State of Alaska  
Department of Fish and Game  
Sportfish Division

Nomination Form  
Anadromous Waters Catalog

Region Southeastern USGS Quad(s) JUNEAU B-3 NE  
 Anadromous Waters Catalog Number of Waterway 111-50-10310  
 Name of Waterway Campground Creek aka Picnic Creek  USGS Name  Local Name  
 Addition  Deletion  Correction  Backup Information

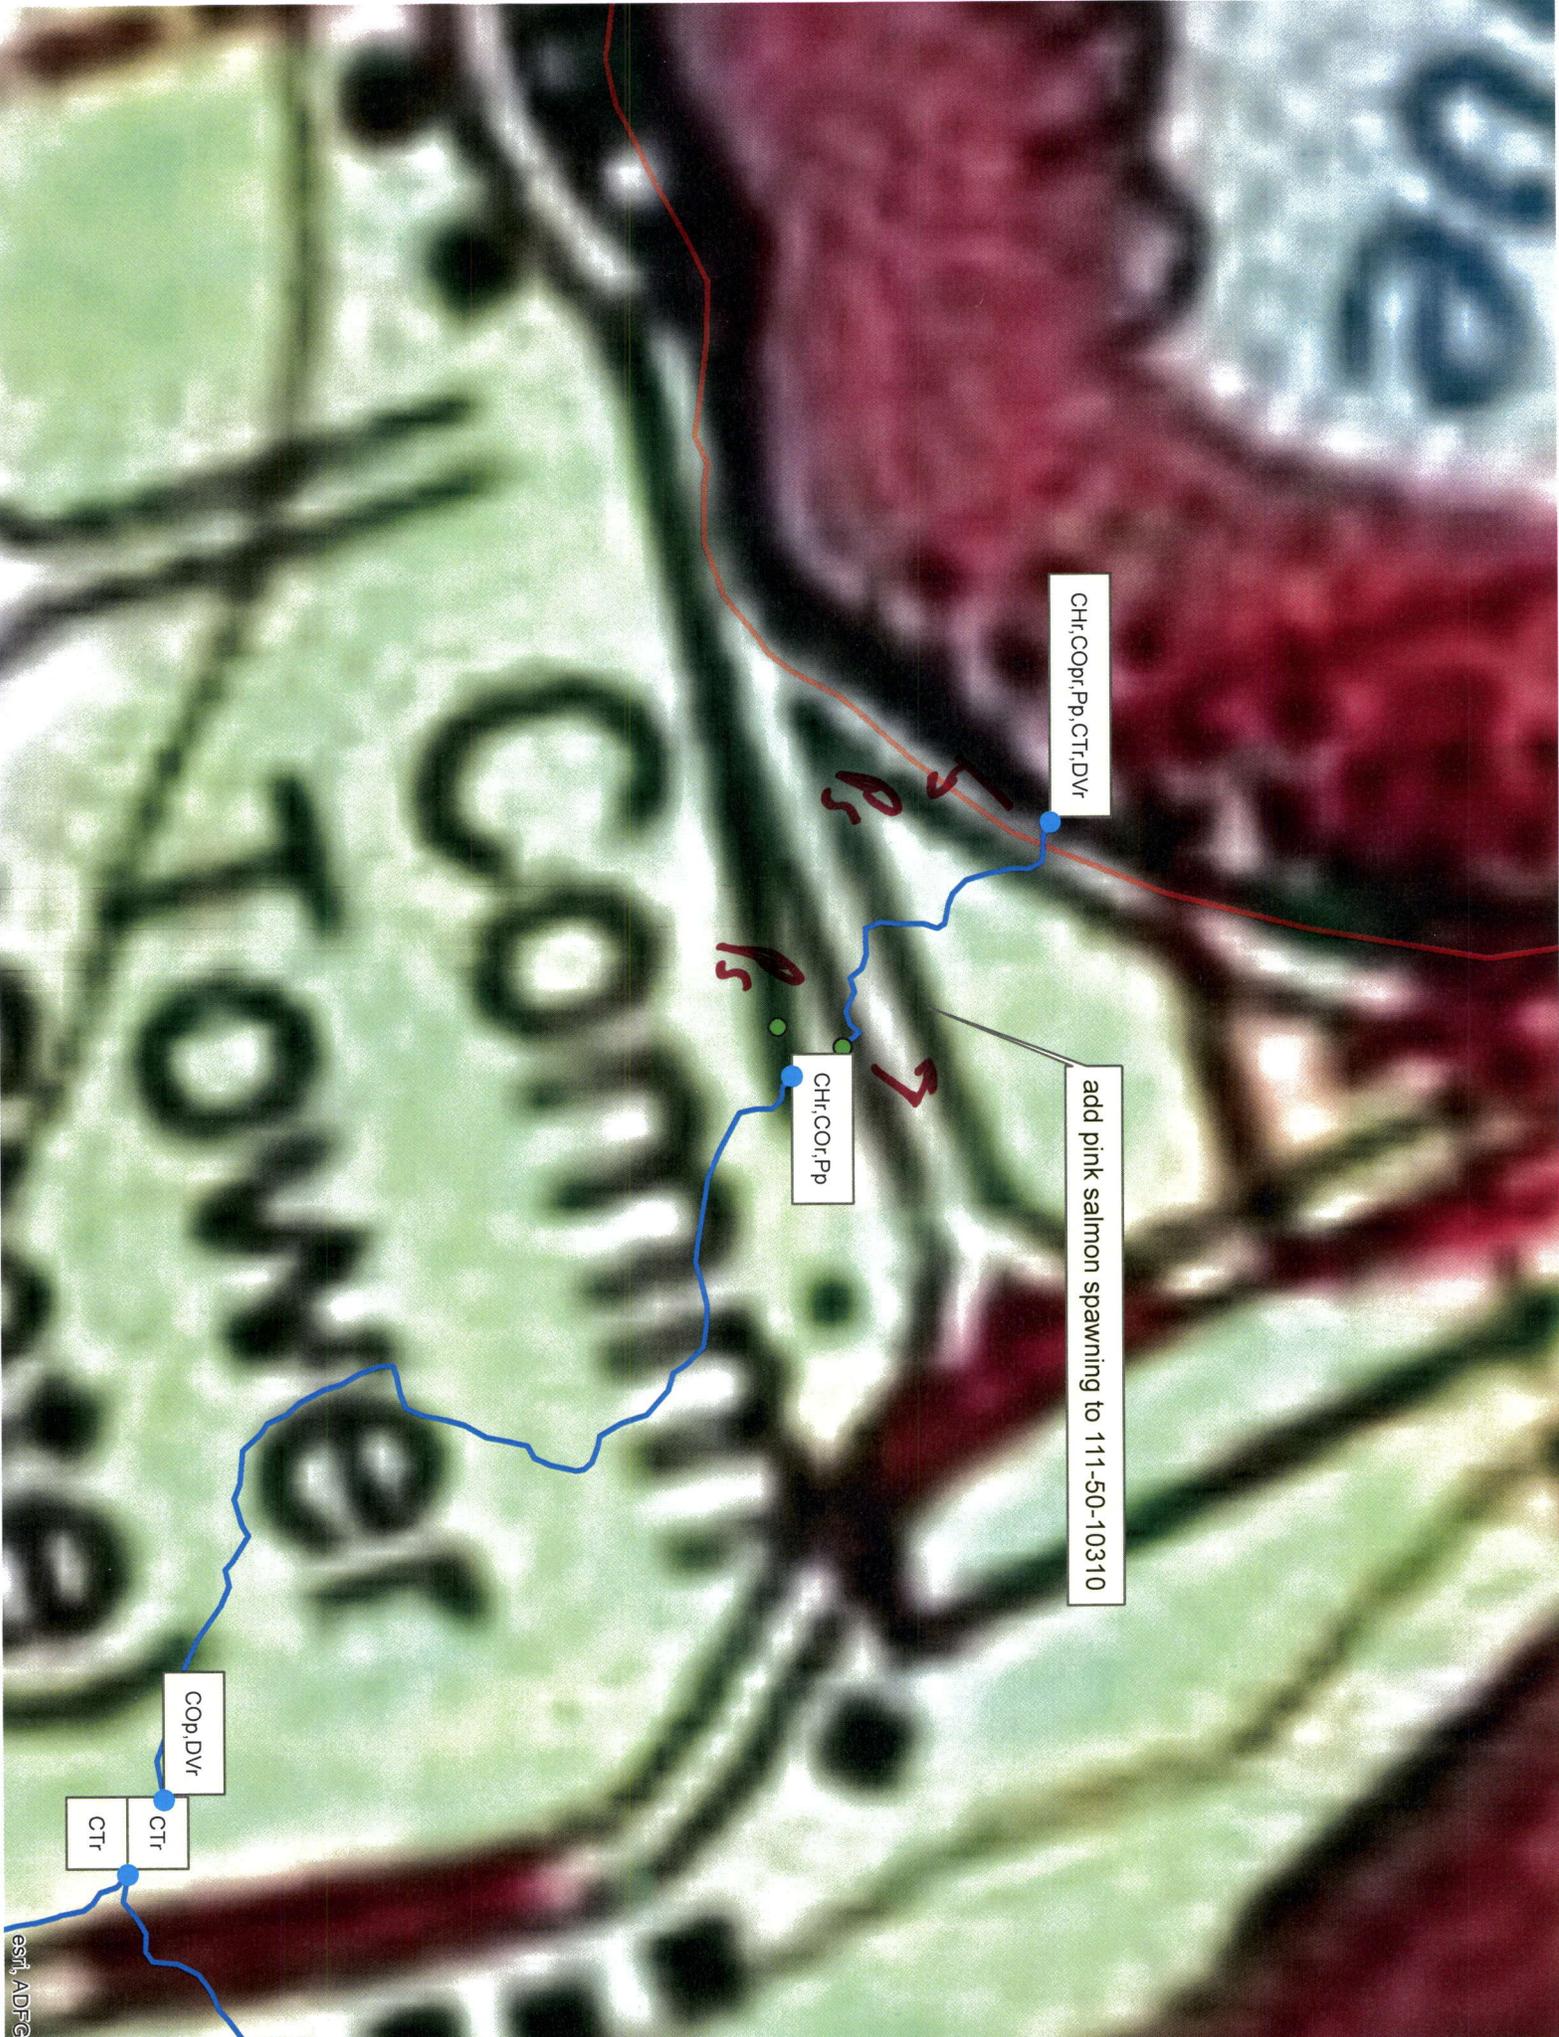
It is unclear from the nomination data just where the upper extent of pink salmon was in 111-50-10310. The map has a blue line, is that the extent of observed spawning?

Yes, the blue line is the extent of the observed spawning. Sorry about including such a rudimentary map. The maps that I have at my disposal do not show 111-50-10310, and our agency mapping program is currently not operational, so I had to draw the creek. The spawning was observed from the mouth of Picnic Creek (58.39325 N, 134.75098 W) to the GPS coordinates 58°23.520N, 134°45.006W. I apologize for any confusion.
